MONTGOMERY COUNTY HISTORIC PRESERVATION COMMISSION
STAFF REPORT

Address:	102 East Kirke Street, Chevy Chase	Meeting Date:	5/14/2025
Resource:	Outstanding Resource Chevy Chase Village Historic District	Report Date:	5/7/2025
Project Contact:	Luke Olson, Architect	Public Notice:	4/30/2025
Review:	HAWP	Tax Credit:	n/a
Permit No.:	1067931 REVISION	Staff:	Dan Bruechert
Proposal:	Fenestration Alteration to Previously Approved HAWP

STAFF RECOMMENDATION

Staff recommends the HPC **with three (3) conditions** the HAWP application, with final approval authority delegated to Staff.

Figure 2: South elevation showing the location of the proposed window and door replacements.

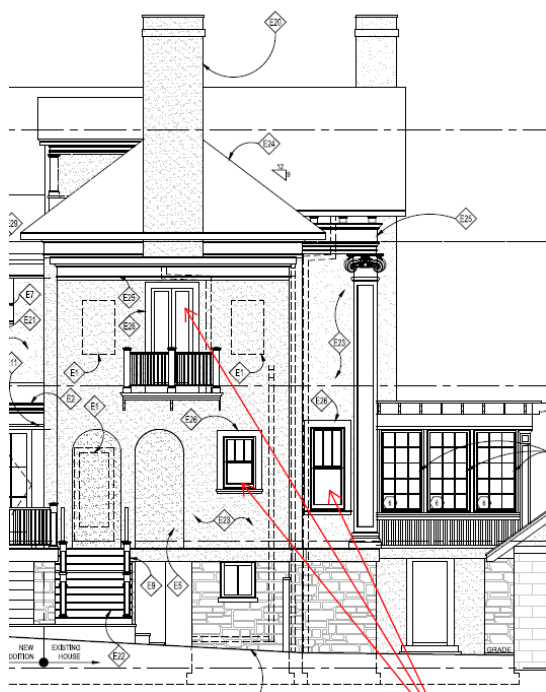
The second floor French Doors (Door #3), shown in *Figure 2*, above, are wood with each door divided up into three lights. The doors show signs of warping and have allowed a significant amount of water infiltration to the point that the interior floors adjacent to the French Doors show substantial damage.

The subject door is not at all visible from the public right-of-way and, per the *Design Guidelines*, is to be reviewed under lenient scrutiny.

Detailed specifications for the replacement doors were not included with the application materials. The application narrative states the proposed door will be a clad wood door to match the existing configuration in SDL divisions.

Because the existing door is not at all visible from the public right-of-way and it shows damage and deterioration, Staff finds its removal is supported under the *Design Guidelines*. Staff further finds an aluminum clad door consistent with the appearance of the approved but uninstalled clad windows on the south and east elevations is appropriate under 24A-8(b)(2) and (d) and the *Design Guidelines*. Staff recommends the HPC add a condition to the approval of this HAWP that detailed door specifications need to be submitted for review and approval before issuance of the final permit documents. Final approval authority can be delegated to Staff to verify the replacement door is consistent with the configuration and dimensions of the existing door.

Figure 3: Eastern elevation showing the proposed replacement windows.

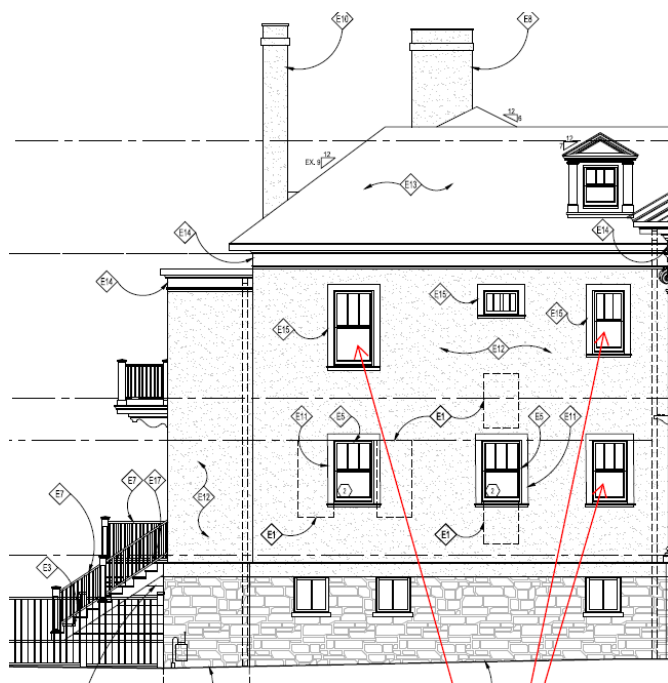
On the south and east elevations, the applicant proposes to remove and replace five existing wood windows (identified as windows 1, 2, 3, 7, and 8 in the application). Three windows are on the east elevation of the existing rear-L (see *Figure 3*, below). One of the windows is on the south elevation of the main house mass and the last window is on the south elevation of the rear ell (see *Figure 2*, above). These windows are not visible from the public right-of-way.

The applicant proposes to install replacement clad wood windows that match the configuration and

dimensions in the existing openings. The application does not specify the reason for the window replacement beyond providing a more uniform level of materiality and detailing on the rear of the house. Staff notes that the HPC has already approved the removal, reconfiguration, and replacement of several windows in the rear ell in the original HAWP.

As discussed in the previous HAWP revision, the *Design Guidelines* state windows not visible from the public right-of-way, as is the case with the windows under consideration in this HAWP revision, should be reviewed under lenient scrutiny, with the exception that windows on Outstanding Resources should be reviewed under strict scrutiny. Under this analysis, windows not visible from the public right-of-way on Outstanding Resources still need to be evaluated under strict scrutiny. In the original HAWP, the Staff recommended the HPC approve the window relocation based in part on the lower level of architectural detail and design significance of the rear ell and because they were not at all visible from within the historic district. The rear ell lacks the columns, decorative modillion cornice, and detailed window trim found on the main house massing. As before, Staff supports the window removal on the east elevation and south elevation of the east ell under 24A-8(b)(2), the *Design Guidelines*, and Standard 2.

WINDOW 4 EXTERIOR VIEW

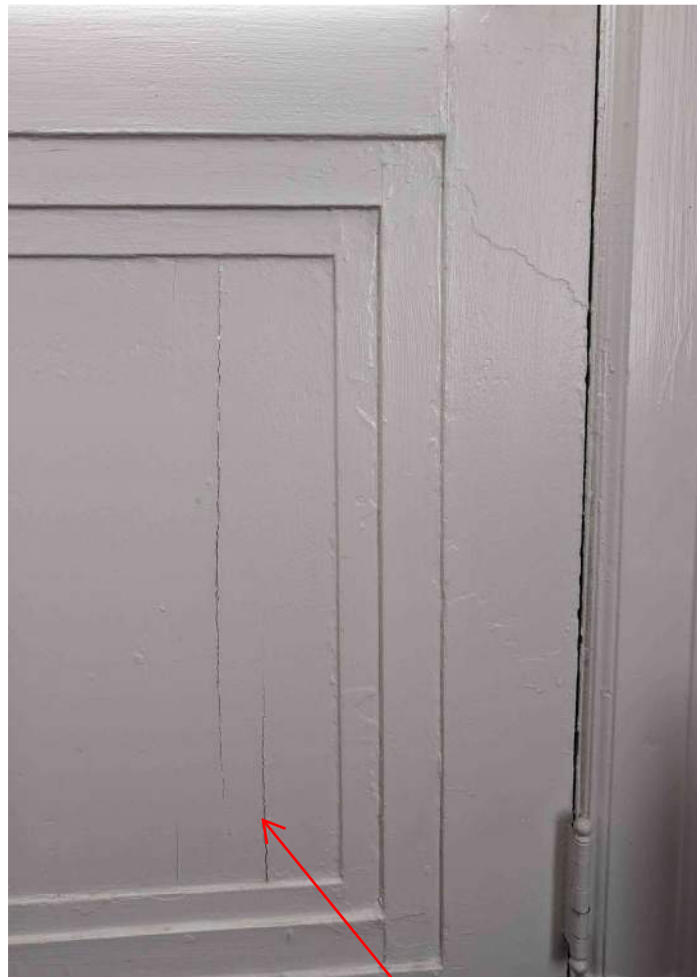
Finally, the applicant proposes to remove and replace three original wood windows and install new wood windows in the existing openings. All three of the windows are three-over-one sash windows, and they are all on the second floor of the house. One window is on the west elevation and two windows are on the east elevation. As with the doors, discussed above, the applicant proposes to remove the windows to improve the thermal performance/comfort of the house, abate traffic noise, and improve security and window operability. The application also states a desire to reduce potential lead paint hazard. Window #4 has a fixed exterior storm window that renders it inoperable

EXG. RETROFIT STORM WINDOW AT WINDOW 4 RENDERING IT INOPERABLE

Under this heightened review standard, Staff does not find that removing the existing windows is appropriate. Nothing provided in the application indicates the windows have deteriorated beyond repair and Staff supports retaining the historic fabric to maintain the house’s material integrity. As with all HAWPs, the burden of persuasion rests with the applicant and Staff does not find that burden has satisfied here.

DOOR 2 INTERIOR VIEW

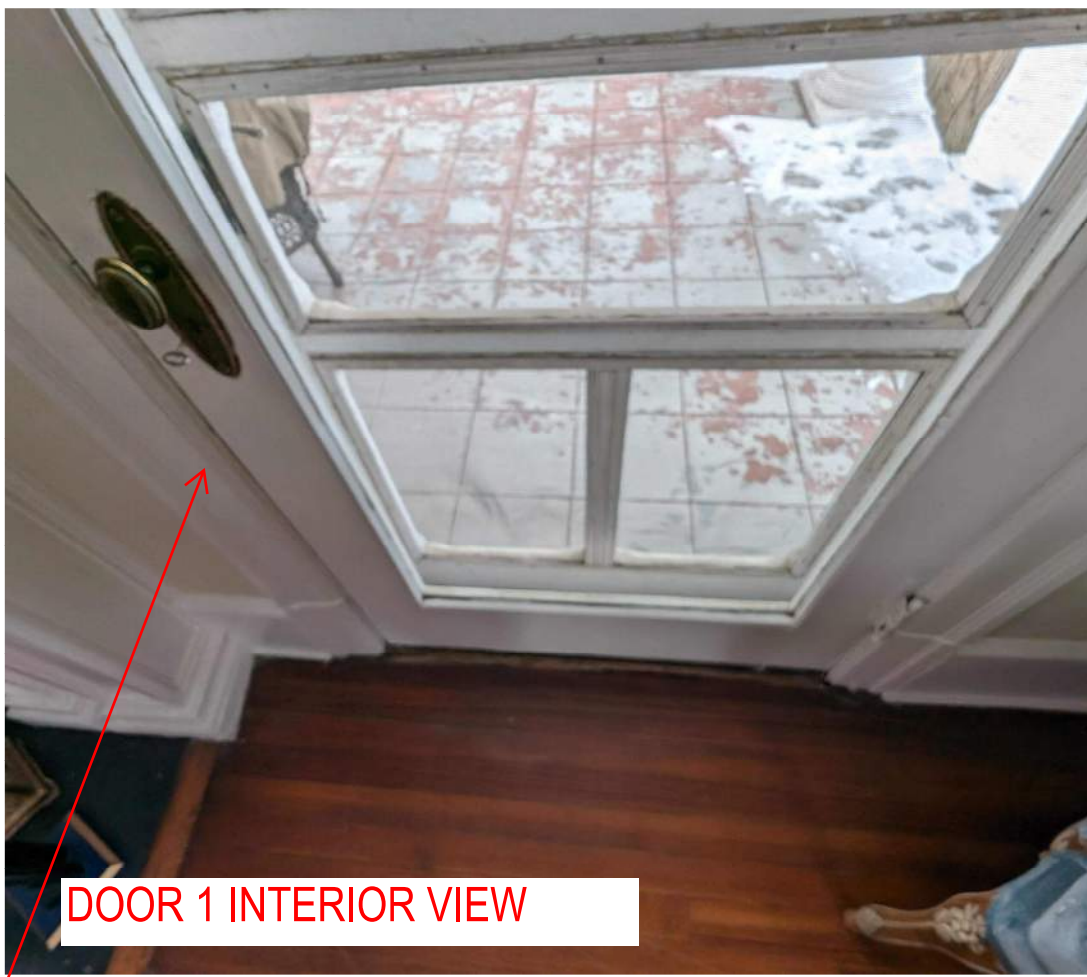
Door #1, on the first floor, is a full light door with a fixed transom. Door #2 is a half-light wood door with fixed transom. The submitted materials show cracks in the lower panel of door #2 on the second floor. The applicant states that the panel is too thin to be effectively repaired with new growth wood. The documentation does not identify any material or structural deficiencies in door #1; however, the accompanying narrative states a desire to improve efficiency, noise abatement, and physical security.

DAYLIGHT VISIBLE THROUGH CRACKS IN PANEL OF DOOR 2

DOORS 1 & 2 ARE OBSCURED BY EXG. SCREEN DOORS AND NOT READILY VISIBLE, DOOR 2 HAS VISIBLE DAYLIGHT SHOWING THROUGH THE CRACKS IN THE WOOD PANEL. I DON'T BELIEVE THERE IS SUFFICIENT THICKNESS TO THAT PANEL GIVEN THE DOOR DESIGN THAT THIS ISSUE WOULD NOT REOCCUR WITH A REPLACEMENT PANEL MADE OF NEW GROWTH WOOD MORE LIKELY TO CUP/WARP/CRACK. WINDOW 4 HAS A RETROFIT CLAD OR VINLY STORM WINDOW INSTALLED ON EXTERIOR RENDERING IT INOPERABLE. WE'D LIKE TO REPLACE THESE UNITS WITH NEW ENERGY-EFFICIENT PTD. WOOD SLD UNITS THAT MATCH THE EXISTING UNITS AS CLOSELY AS POSSIBLE TO MAINTAIN THE LOOK/AESTHETICS FROM THE EXTERIOR WHILE ALSO PROVIDING A HIGHER DEGREE OF AIR/WEATHERSEALING FOR ENERGY-EFFICIENCY, FUNCTIONALITY/USEABILITY, AND COMFORT.

Based on the submitted information, Staff finds that door #2 shows damage that cannot be readily repaired and the finds that removing and replacing the door is appropriate under the *Design Guidelines* and *Standard #6*. However, the applicant has not provided detailed specifications for the proposed replacement door and Staff recommends the HPC add a condition that requires the applicant to submit detailed specifications for the wood replacement door to Staff before final approval documents can be released. Final approval authority can be delegated to Staff to verify the proposed door is consistent with the existing door.

Staff does not find the applicant has demonstrated that the door #1 has deterioration beyond repair and notes that under moderate scrutiny the integrity of the resource is considered. If there are other concerns or mitigating factors to consider, Staff encourages the applicant to provide those to the HPC. Staff notes repainting and weather stripping the door coupled with a properly fitted storm door would improve the thermal performance and the security of the existing door. Staff does not recommend the approval of this HAWP extend to removing and replacing door #1.

WINDOW 5 EXTERIOR VIEW

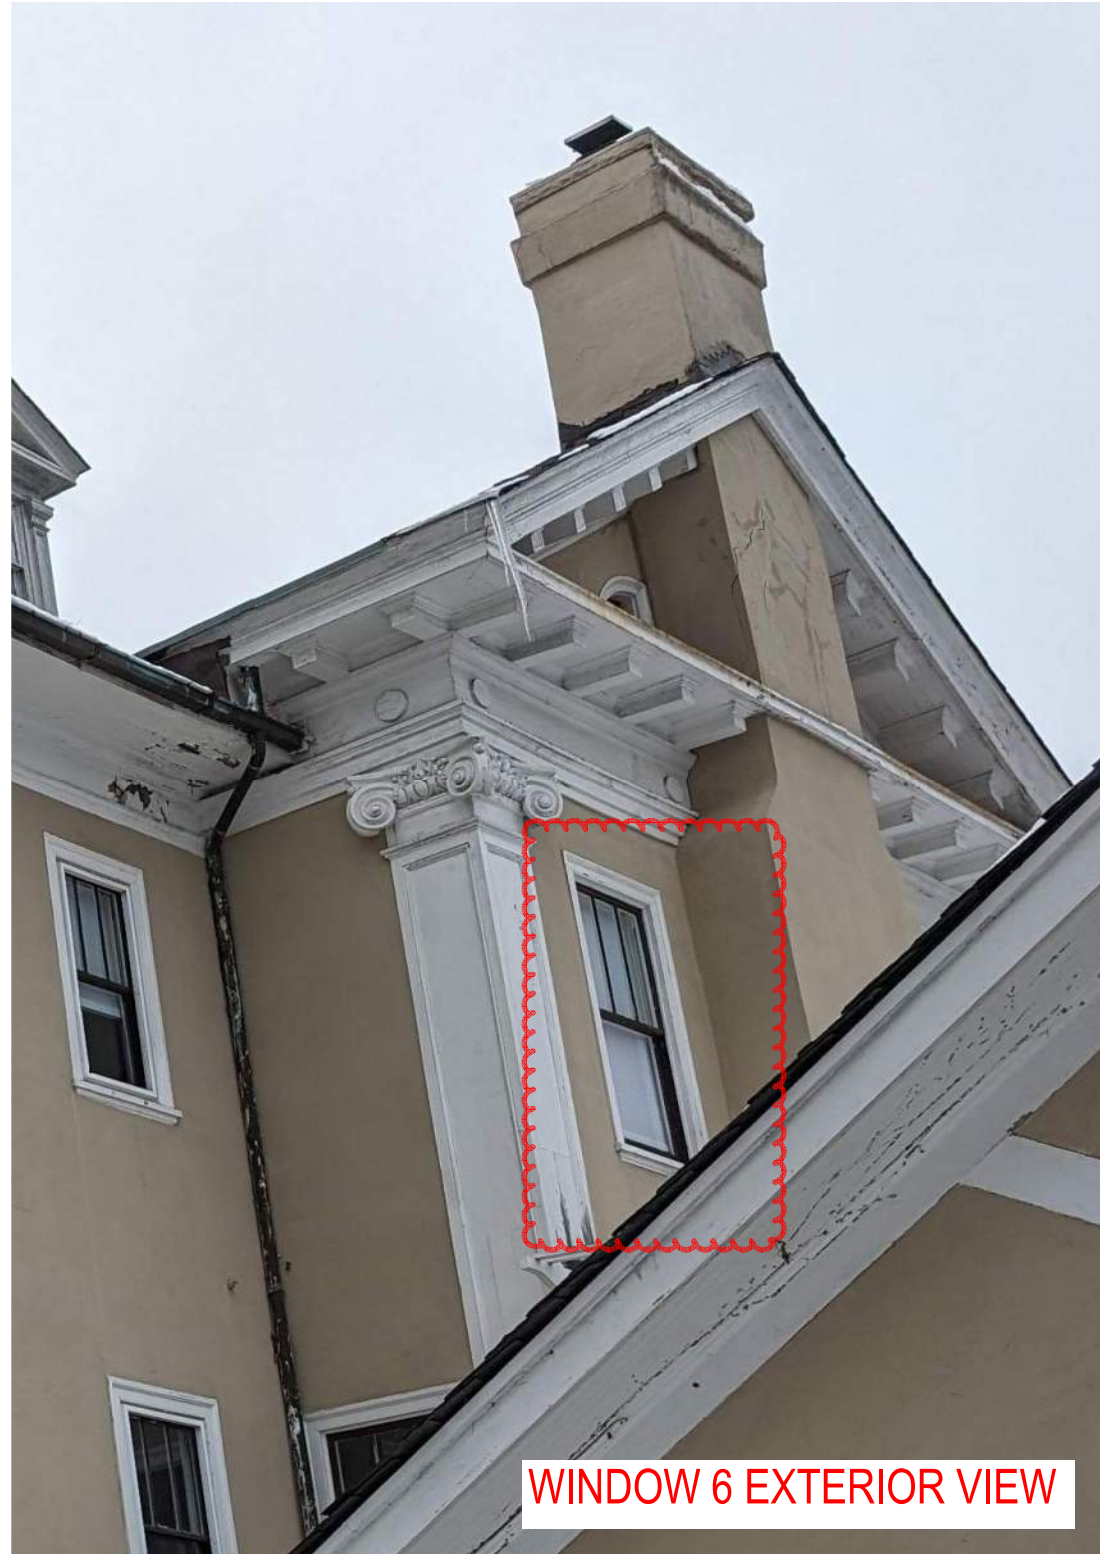
WINDOWS 5 & 6 ARE NOT READILY VISIBLE, DOOR 2 HAS VISIBLE DAYLIGHT SHOWING THROUGH THE CRACKS IN THE WOOD PANEL. WE'D LIKE TO REPLACE THESE UNITS WITH NEW ENERGY-EFFICIENT PTD. WOOD SLD UNITS THAT MATCH THE EXISTING UNITS AS CLOSELY AS POSSIBLE TO MAINTAIN THE LOOK/AESTHETICS FROM THE EXTERIOR WHILE ALSO PROVIDING A HIGHER DEGREE OF AIR/WEATHERSEALING FOR ENERGY-EFFICIENCY, FUNCTIONALITY/USEABILITY, AND COMFORT.
